**SUBJECT: R.E. Ginna Nuclear Power Plant**  
Docket No. 50-244

Application to Revise Technical Specifications Regarding Control Room Envelope Habitability in Accordance With TSTF-448, Revision 3, Using the Consolidated Line Item Improvement Process

**Proposed Technical Specification Changes (Mark-UP)**

Figure B 3.7.9-1  
CREATS

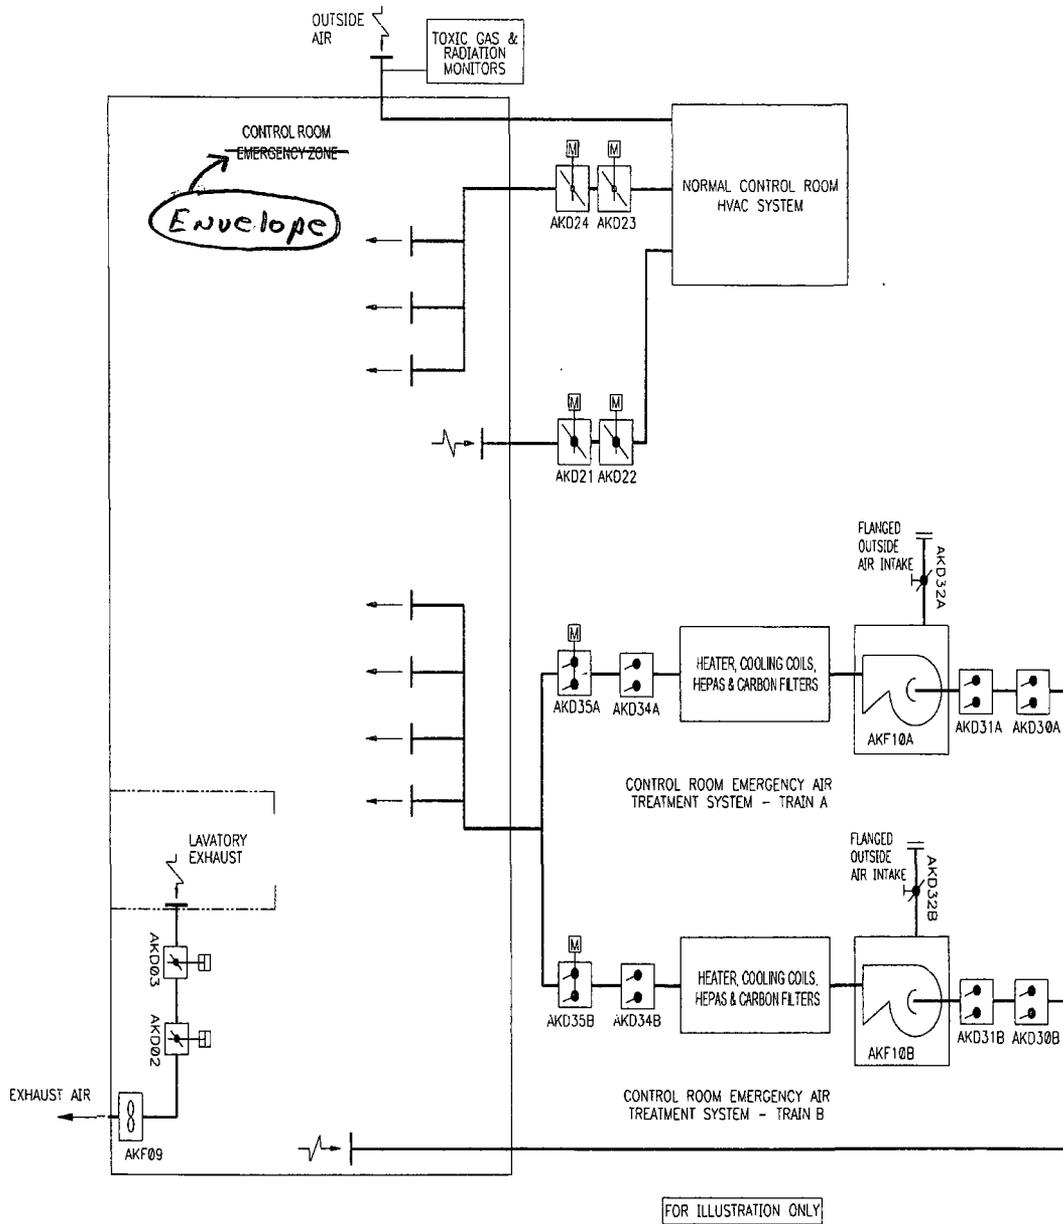
The CREATS consists of two trains, each containing a high efficiency particulate air (HEPA) filter, activated charcoal adsorbers for removal of gaseous activity (principally iodines), and one fan (see Figure B 3.7.9-1). Ductwork, dampers, and instrumentation also form part of the system (Ref. 3).

~~The CREATS is considered OPERABLE when the individual components necessary to permit CREATS operation are OPERABLE (see Figure B 3.7.9-1). A CREATS train is OPERABLE when the associated:~~
